Town of Carrboro

Meeting Agenda Board of Aldermen

Tuesday, March 8, 2016

1. [16-085](#) Continuation of Public Hearing Regarding a Major Modification Request for an existing Conditional Use Permit at 107 Padgette Lane thereby allowing construction of a 5-story Hilton Hotel as well as expansion of the existing 300 E. Main St. parking garage.

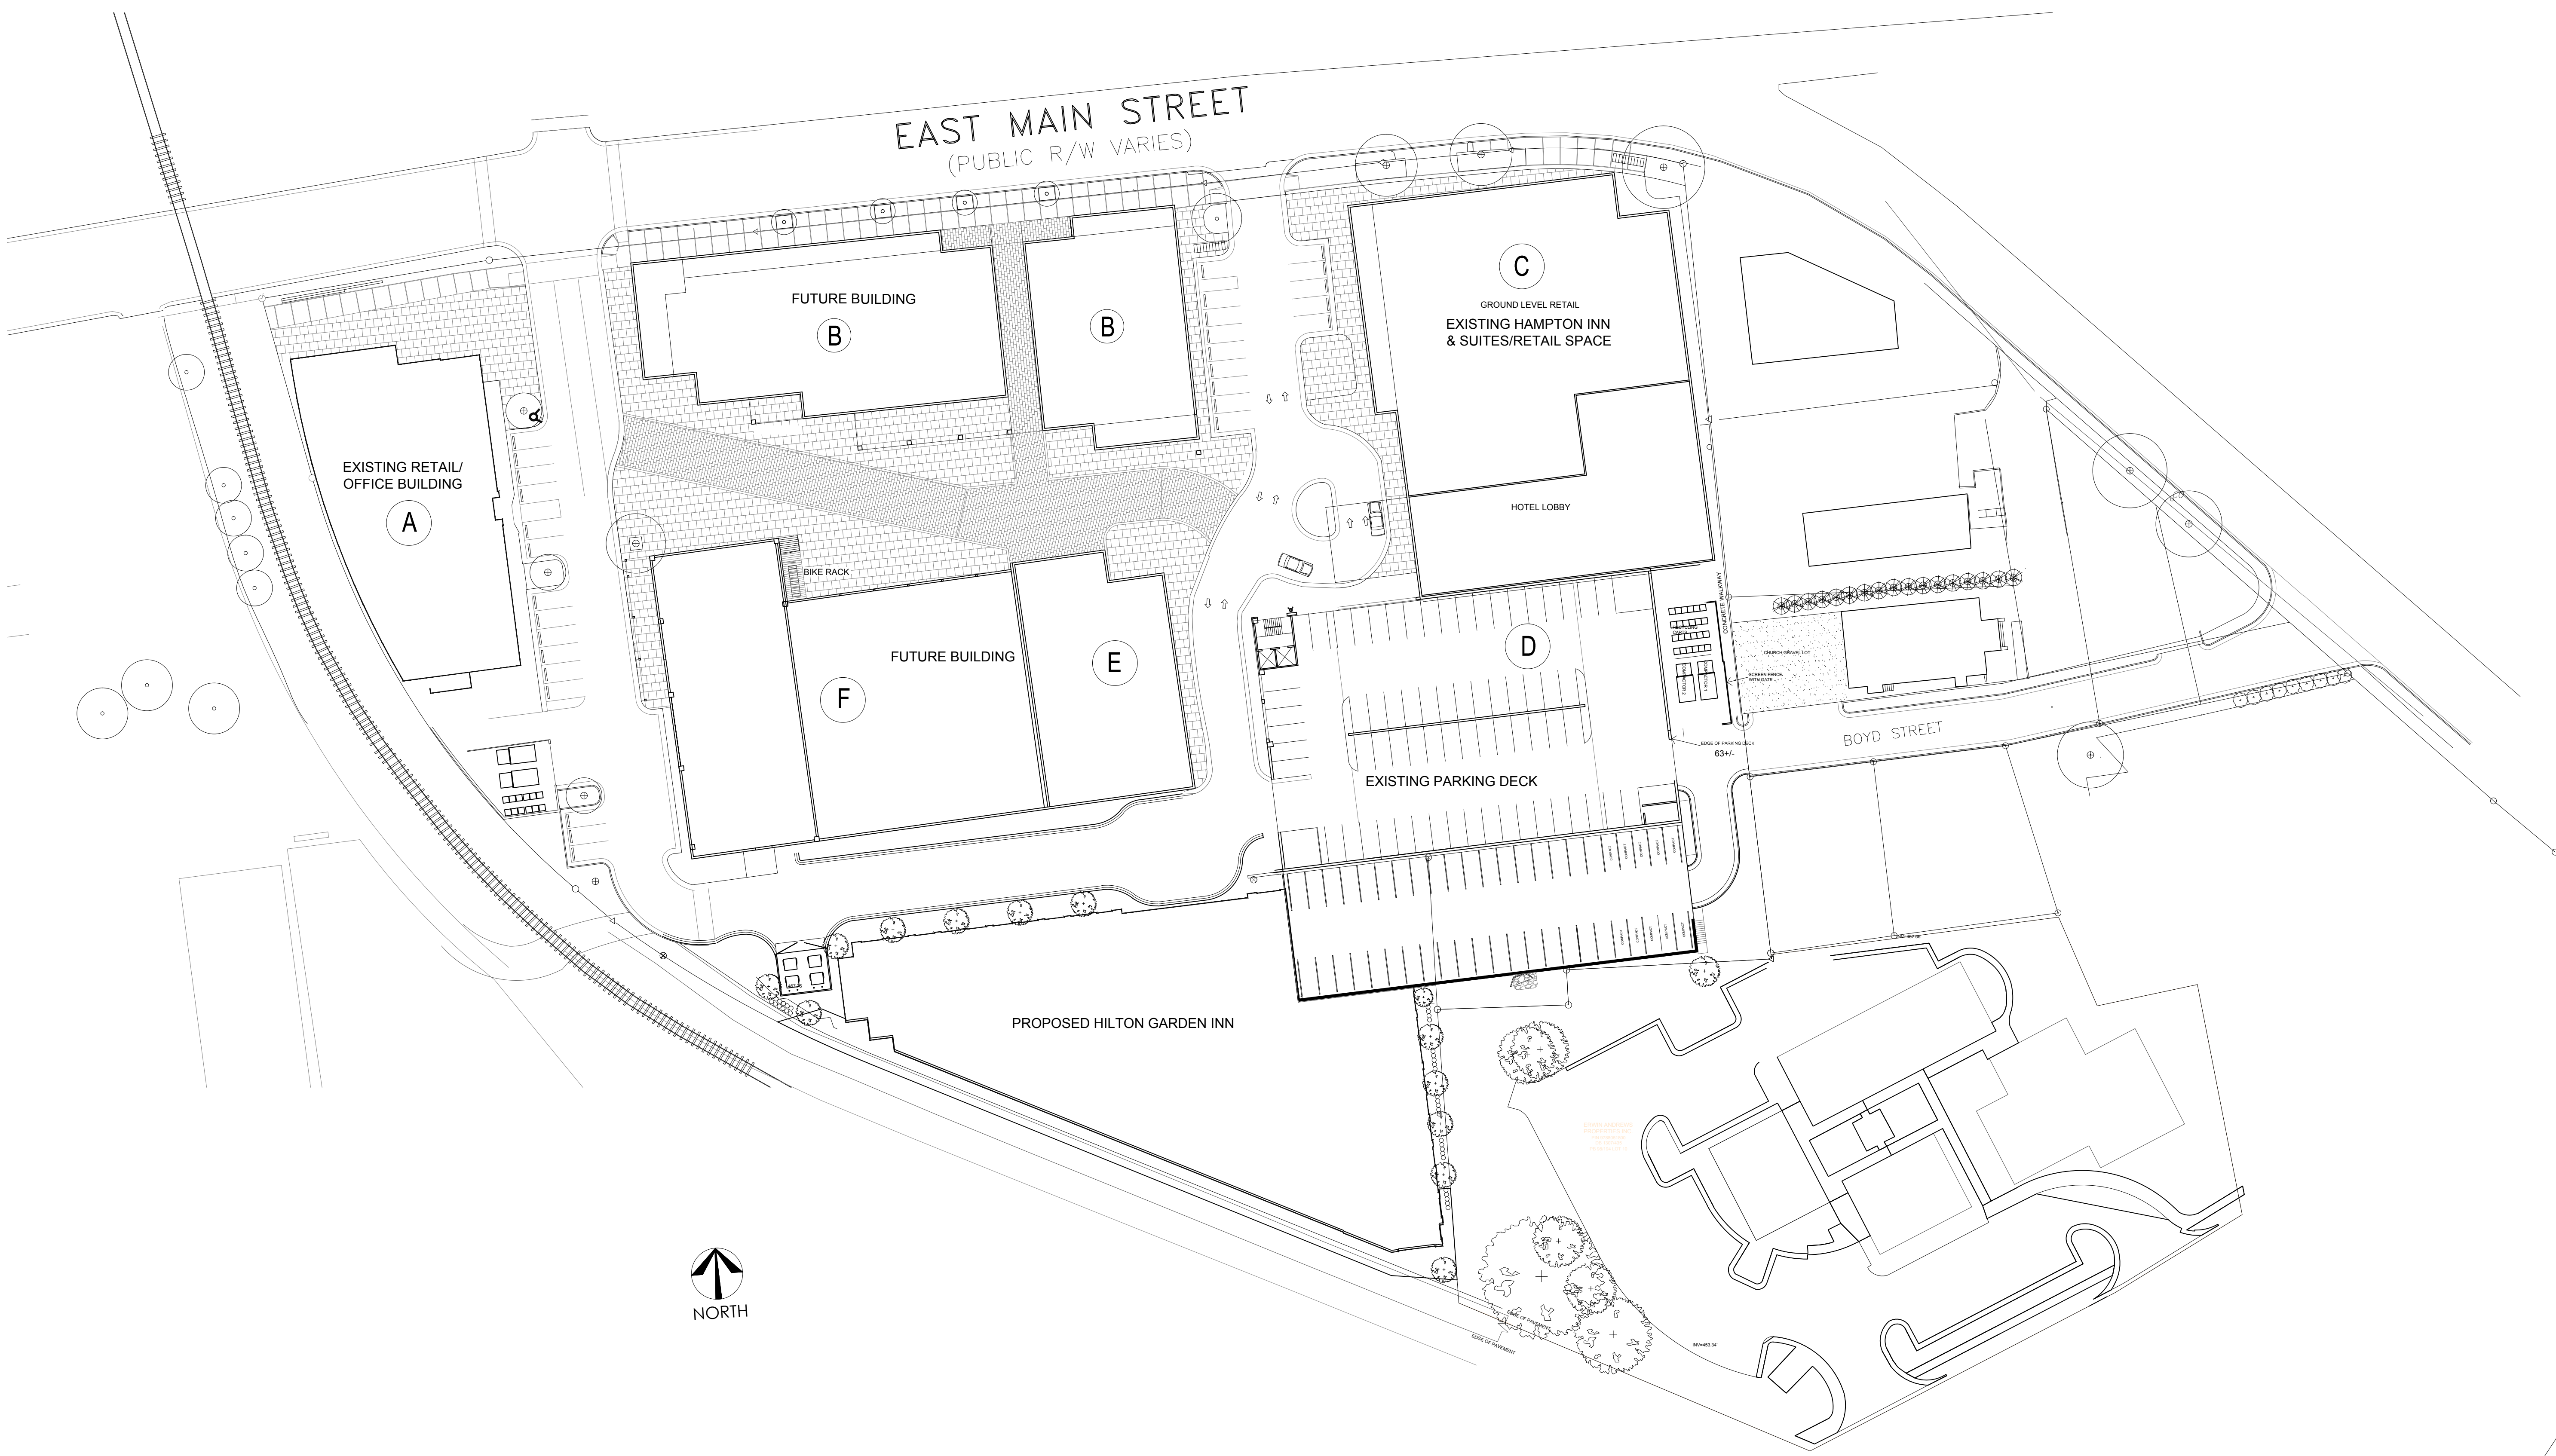
9. Please consider making the connector path from the bikeway wider.

The connector has been widened to 8 feet wide (from 5 feet). Also keep in mind that the connector path shown on the Hilton Garden Inn site plan is a temporary condition. At full build-out there will be a flatter, wider connection to the north (see attached plans incorporating HGI into approved 300 East Main CUP).
